Discuss and take appropriate action regarding Change Order No. 7 for Williamson County Regional Park.

RE: Williamson County Regional Park

The following synopsis is a breakdown for Change Order #7.  
This following are topics for discussion at the Commissioner's Court Meeting on 2/11/03 with Land Strategies, Inc.

## Change Order #7

# PROPOSAL REQUEST

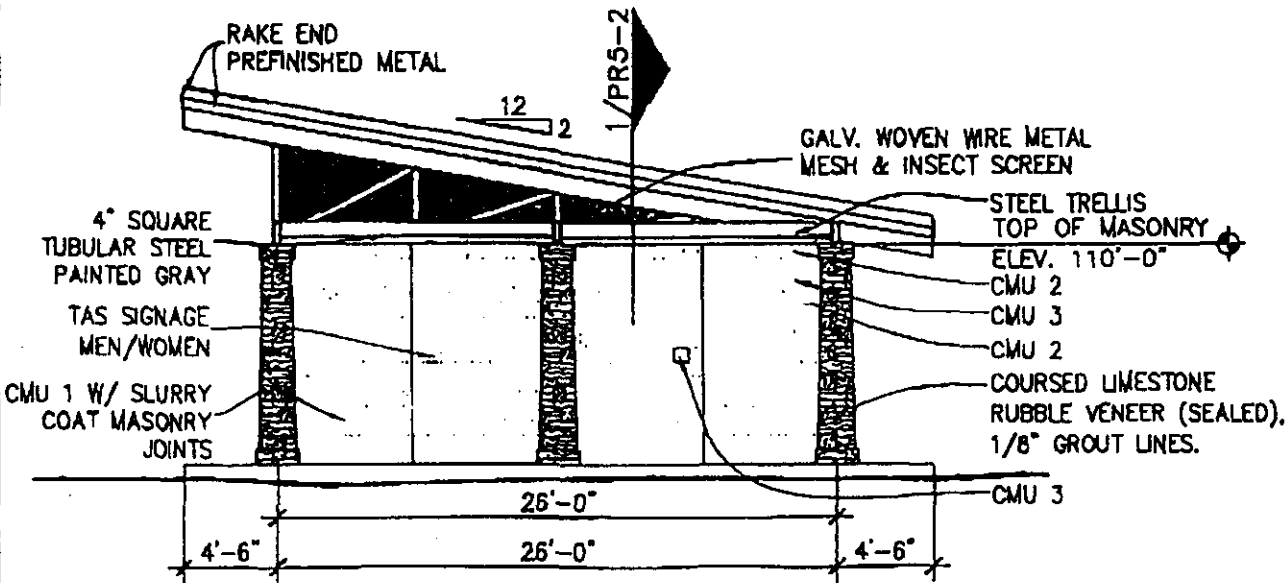
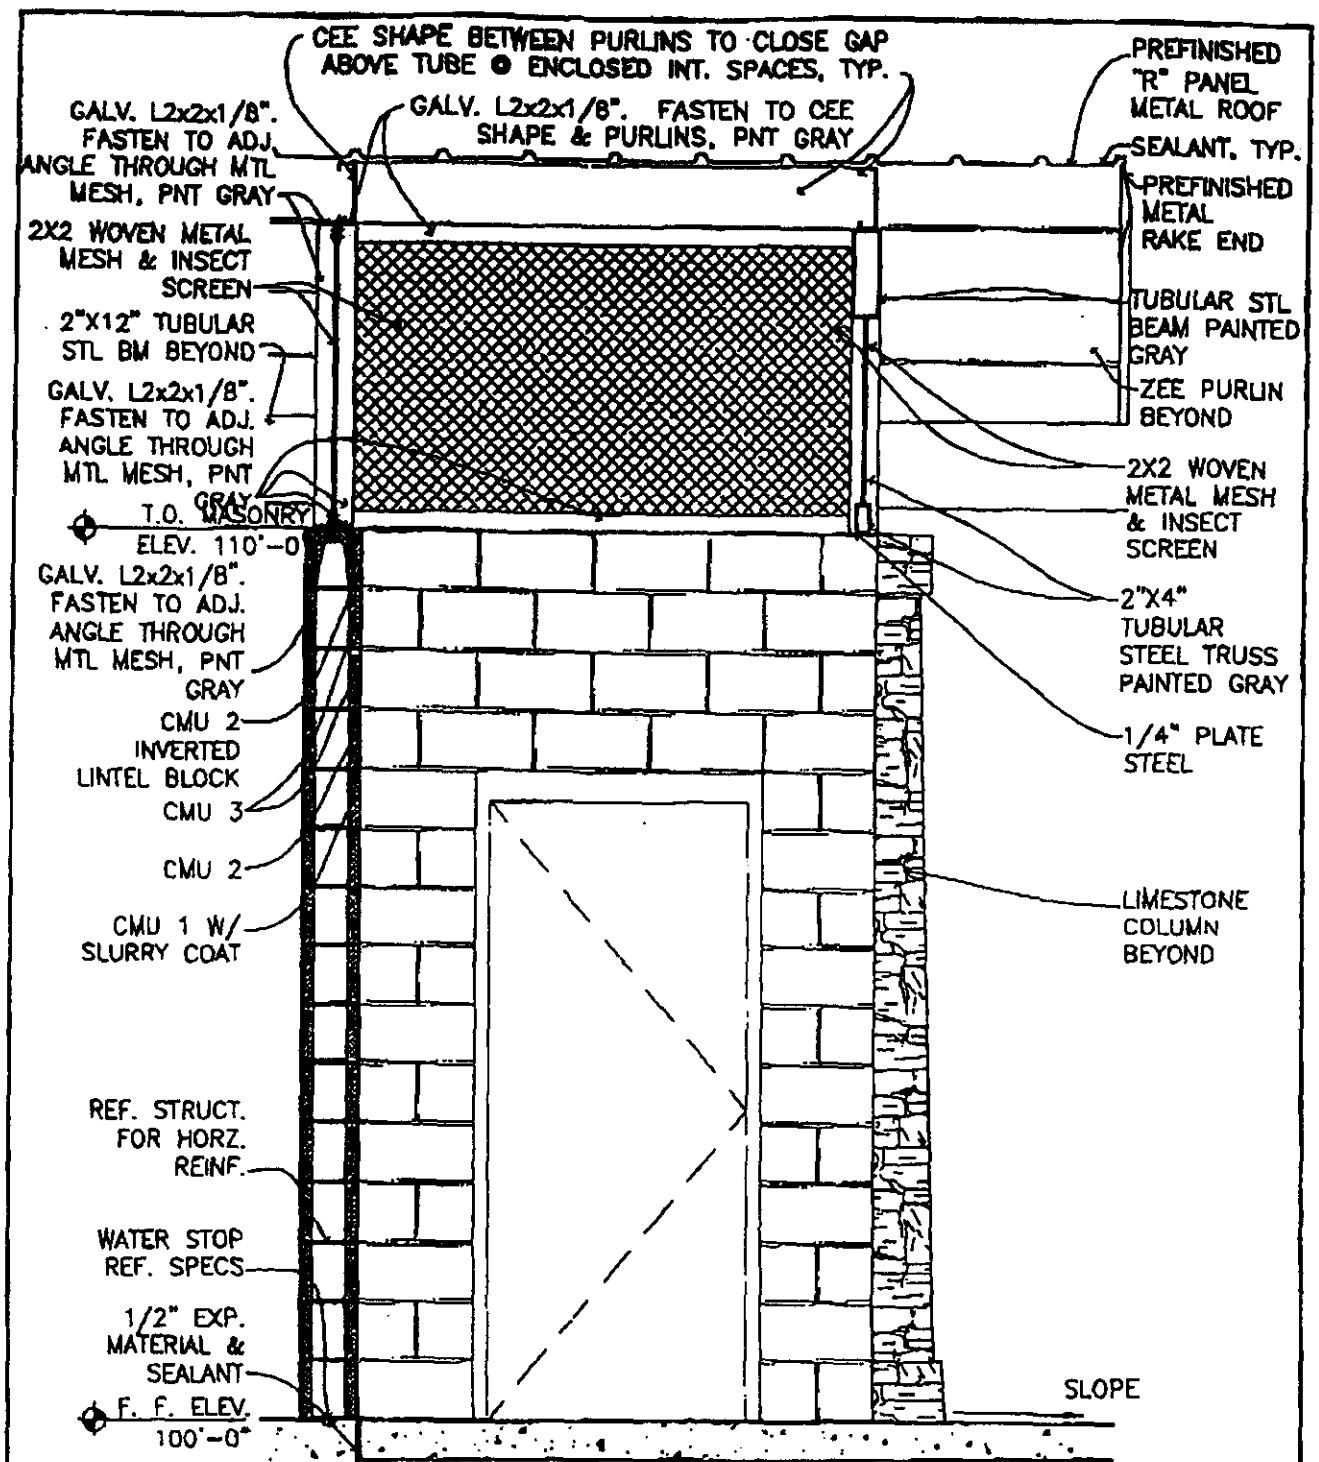
This change incorporates miscellaneous changes to Building H at the Williamson County Regional Park project. This includes: all labor, material, equipment, supervision and incidentals required to install a mesh partition at the entry to the restrooms. Mesh partition shall be installed in horizontal position acting as a soffit in the entry area. Mesh partition to be constructed using similar materials as the vertical partitions installed in other buildings. This change is derived from Moman Architect's RFP dated 12/31/02. Mesh partition shall be installed in the horizontal position in lieu of the vertical position as shown on Moman Architect's RFT dated 12/31/02. Please see attached.

Provide the cost to construct a screen above the block wall that forms an alcove for the toilet room entries for building "H," the concession storage building. Reference attachments.

Attachments:  
(List attached documents that support description.)  
Drawings- PR5.1 and PR5.2 dated 12/31/02.

Please find below Construction Metal Products's cost to furnish and install a flat partition at building "H". Our cost is based on a partition 5'-8" X 13'-4" which will attach to main wall.
